Operational Alert: 173

Subject: Trim Wire Breakage

Models Affected: All Models using Push-Pull Wire Trim System

FIGURE 1 - Proper installation of Wire Swivel allows free rotation.

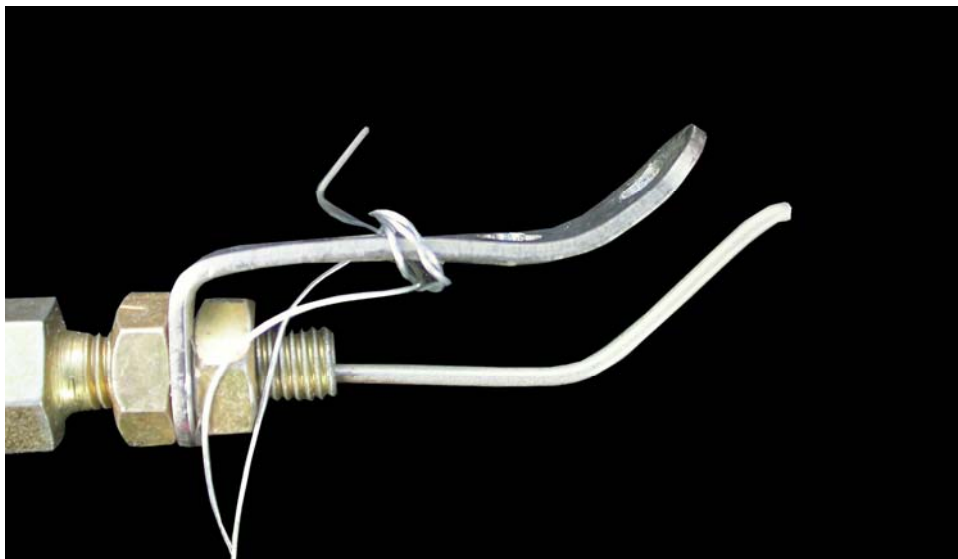
1. Inspect during pre-flight. Look closely at the wire where it terminates at the wire swivel. This should be secure and properly assembled with appropriate hardware. The intent of the design is to capture the wire with the wire swivel, while allowing the wire swivel to pivot freely in the trim tab horn. **IMPORTANT:** *The wire swivel must pivot freely when the trim wire is final installed with the wire swivel retaining screw fully tightened.* Refer to **FIGURE 1**.
2. Replace any suspect push-pull wire with proper spec wire. Contact RANS Parts Department to order.
3. If the push-pull wire has been bent, it needs to be replaced. See **FIGURE 2**.
4. Consider installing an electric trim servo. Several builders have created systems to install the Ray Allen brand of servos. We may be offering a factory made kit for this option.
